UN Regulation No. 127 (Pedestrian safety)

Proposal for supplement 4 to the 03 series of amendments to UN Regulation No. 127 (Pedestrian safety)

Submitted by the experts from Germany and the Kingdom of the Netherlands *

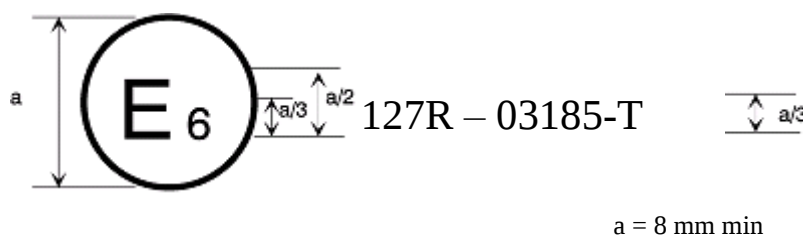
Annex 1, Part 2, paragraph 16.1., amend the text under the table to read:

"WAD 2,100 boundary in accordance with paragraphs 11.9. to 11.~~11~~.13.: applicable / not applicable."

Figure 6
Evaluation of resultant acceleration and jerk for tests to the windscreen.

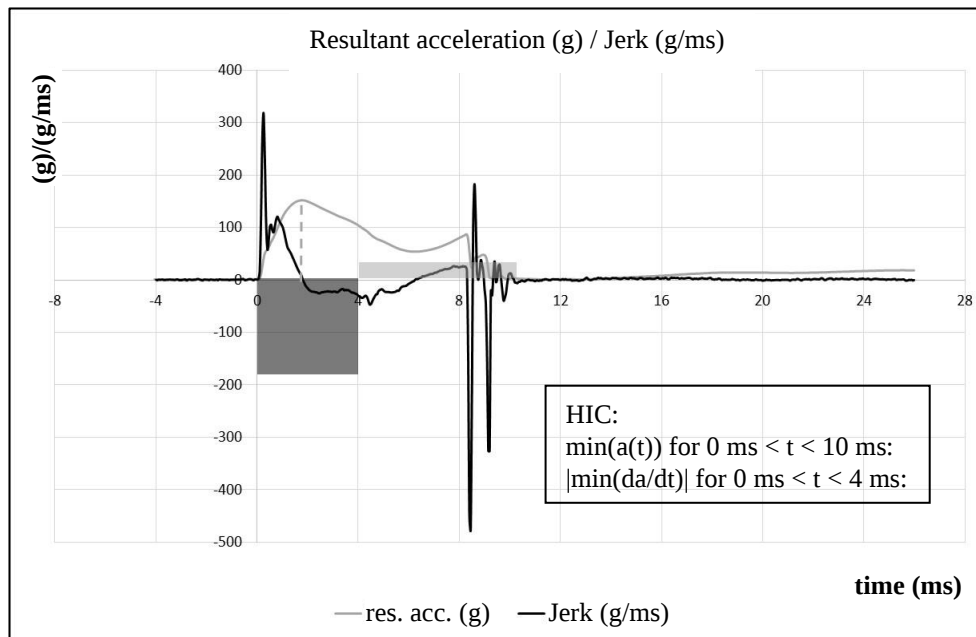
- "4.1. Tests shall be made to the front structure within the boundaries as defined in paragraph 2.16. of this Regulation. Test shall also be made to the windscreen within the boundaries as defined in paragraph 2.44. **For all tests to the windscreen, resultant acceleration versus time and jerk (derivation of the resultant acceleration) versus time histories must be provided and evaluated against the atypical fracture criteria according to paragraph 2.48. (see Figure 6) and reported for monitoring purpose according to paragraphs 4.8. to 4.10.** For tests on the rear area of the bonnet top, the headform impactor shall not contact the windscreen or A-pillar before impacting the bonnet top. For tests on the windscreen, the headform impactor shall not directly contact the A-pillars, windscreen header and cowl, except in the case of monitoring testing.

- “5.1. Tests shall be made to the front structure within the boundaries as defined in paragraph 2.1. of this UN Regulation. Tests shall also be made to the windscreen within the boundaries as defined in paragraph 2.44. **For all tests to the windscreen, resultant acceleration versus time and jerk (derivation of the resultant acceleration) versus time histories must be provided and evaluated against the atypical fracture criteria according to paragraph 2.48. (see Figure 6) and reported for monitoring purposes according to paragraphs 4.8. to 4.10.** For tests at the rear of the bonnet top, the headform impactor shall not contact the windscreen or A-pillar before impacting the bonnet top. For the tests on the windscreen, the headform impactor shall not directly contact the A-pillars, windscreen header and cowl, except in the case of monitoring testing.”

Note: Both alternatives, 1 graph for each criterion or 1 graph for both criteria, are accepted.”
